REVIEW COMMENTS

FILE #SPR-95-171

TITLE HEADING: Site Plan Review - New Building for
Light Manufacturing/Storage

LOCATION: 2384 Leland

SMJ INC Drawing Title: LANDSCAPING DETAIL	Approved By:	Scale: NTS	Drawn by: D.Jenkins	P.O. Number:
	Customer Name:	Drawing Number:	Date: 09/20/95	Sequence Number: 09/20/95

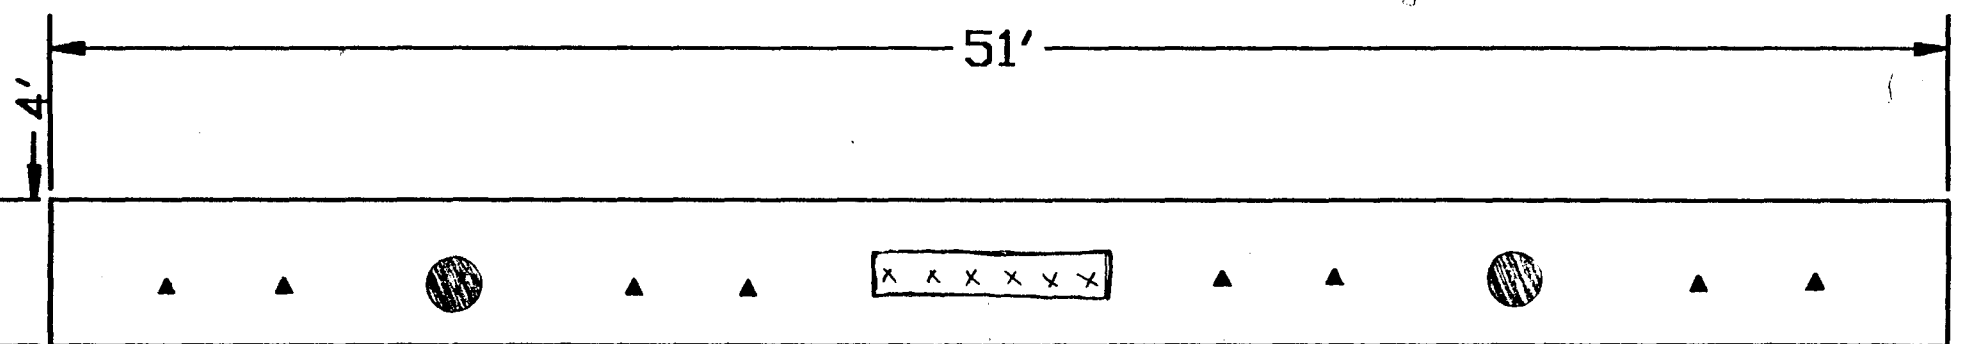
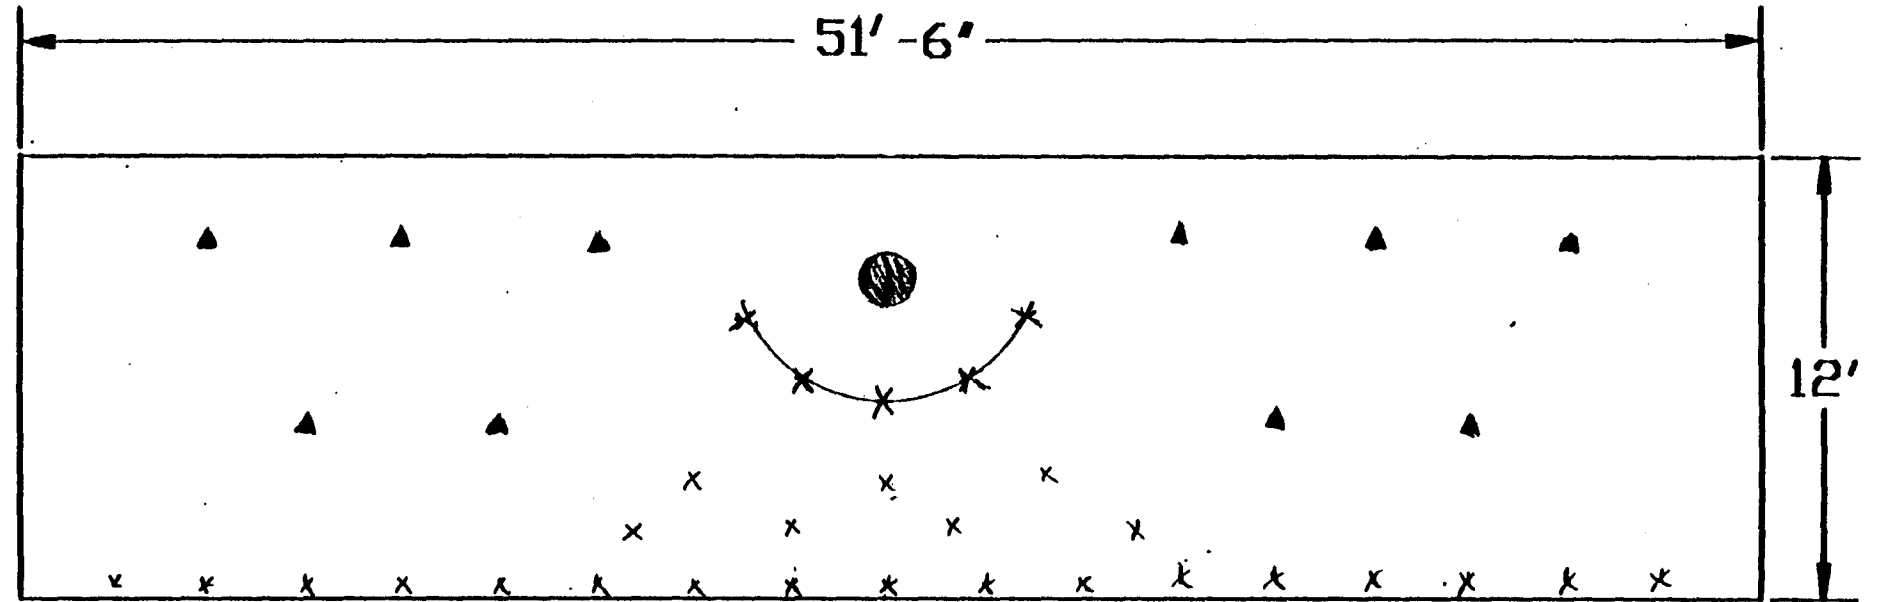
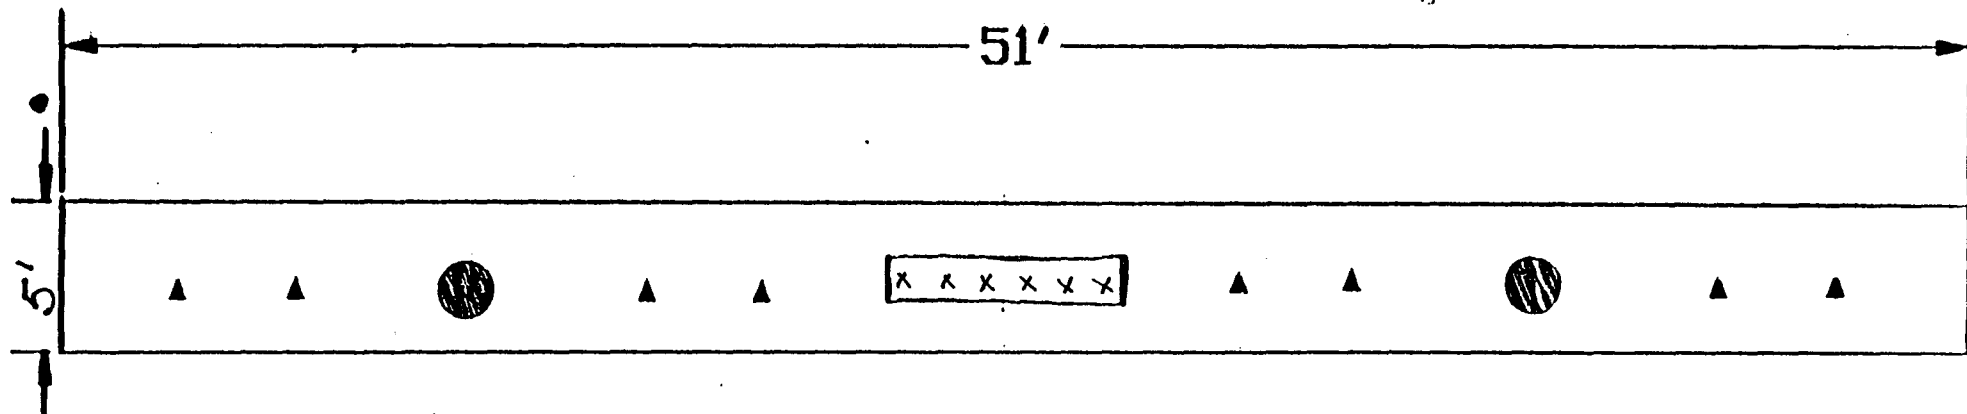
Please note on the landscape detail sheet that the landscaped areas will be irrigated with an underground, pressurized irrigation system and that the trees will be a minimum 1-1/2" caliper planting size and the shrubs a minimum 5 gallon planting size.

* These areas will be irrigated by an underground, pressurized system

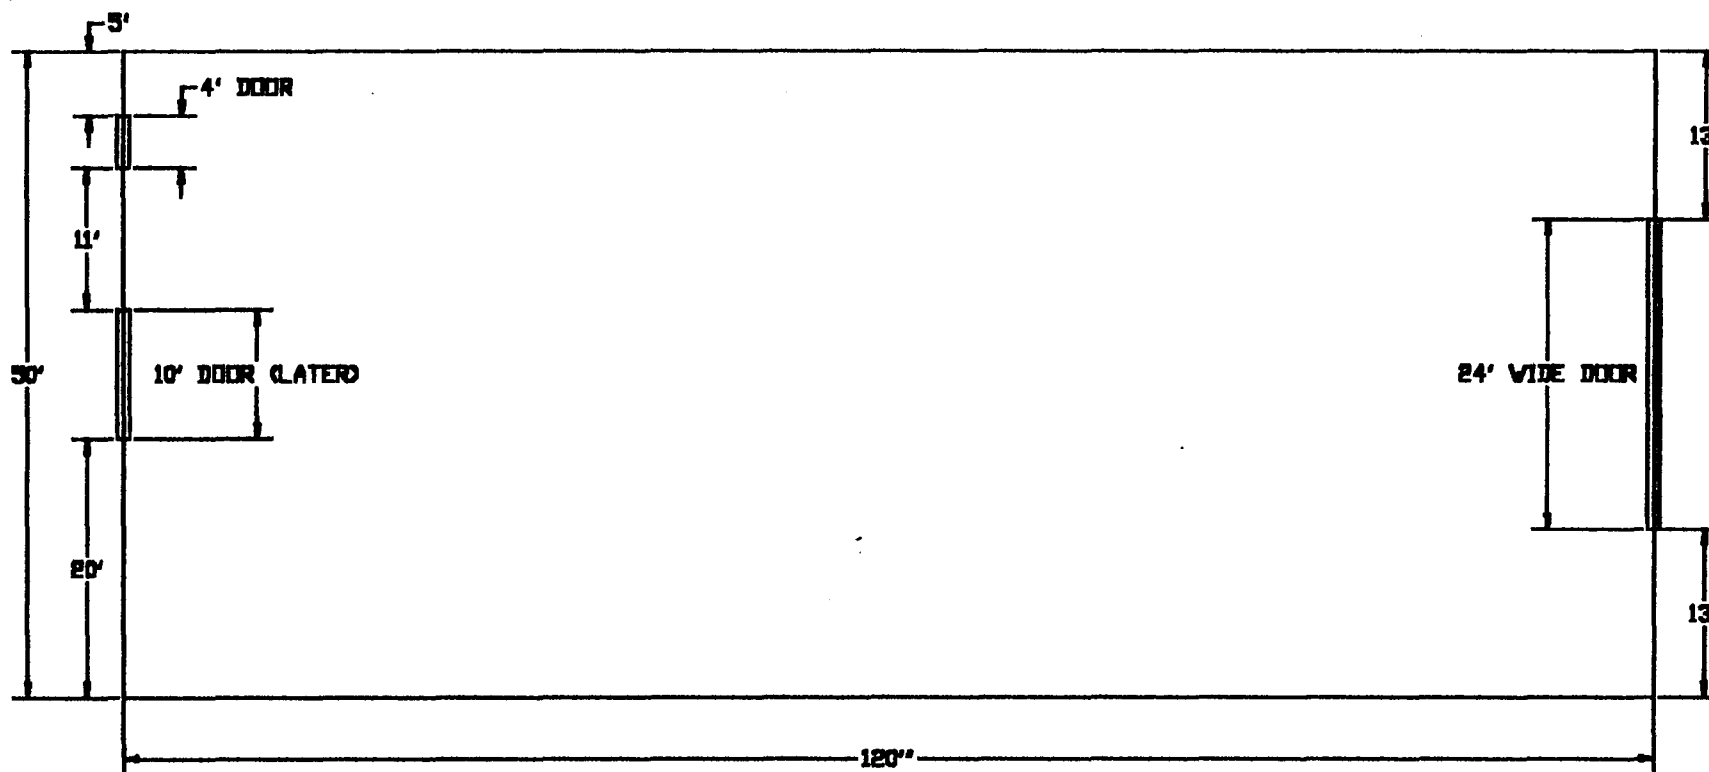
PARKING / PAVING

Paved parking area must include a backing area for the westerly most space in order for a vehicle to maneuver and get out of the space.

Show where edge of pavement of Leland is relative to paved parking area. The driveway between the street and the parking area must also be paved.

Will the existing fencing remain? If so, please revise plan to indicate this.
